Ribble Valley Borough Council
Council Offices
Church Walk,
Clitheroe
Lancashire
BB7 2RA

Phone: 0300 123 6780
Email: developeras@lancashire.gov.uk
Your ref: 3/2026/0214
Our ref: 3/2026/0214/HDC/KW
Date: 04 June 2026

Location: Land at Albany Drive Copster Green BB1 9EH
Proposal: Proposed erection of 26 affordable dwellings with associated access, gardens, parking and landscaping.
Grid Ref: 367420 433582

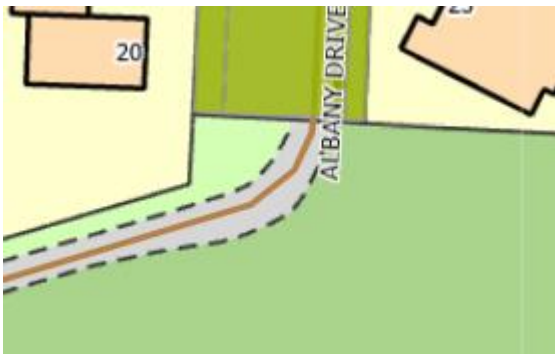
Below is an enclosed abstract of the LHAs adoption records. There appears to be a ransom strip between the proposed location plan red edge and the adoption line. This will need to be reviewed and amended where necessary and any necessary third-party landowners will need to party to the section 38 agreement.

- Traffic Survey, including traffic speeds and volumes on Lovely Hall Lane.
- Resubmission of visibility details and amendments to ensure vegetation and boundary treatments do not obstruct visibility splays at a junction off the primary internal carriageway, as well as a number of private driveways across the site
- Provision of improved pedestrian access alongside parking areas, ensuring sufficient width (typically 5.7–6.0 m for two vehicles and pedestrian movement) and avoiding reliance on neighbouring driveways.
- Clarification of the southern extent of the access road, including provision of a suitable turning head and defined access arrangement for agricultural land.
- Provision of Vehicle Restraint Systems (VRS) adjacent to drainage features where required to ensure safety.
- An review of the red edge boundary, amendments should be made to ensure it meets the adopted highway line.
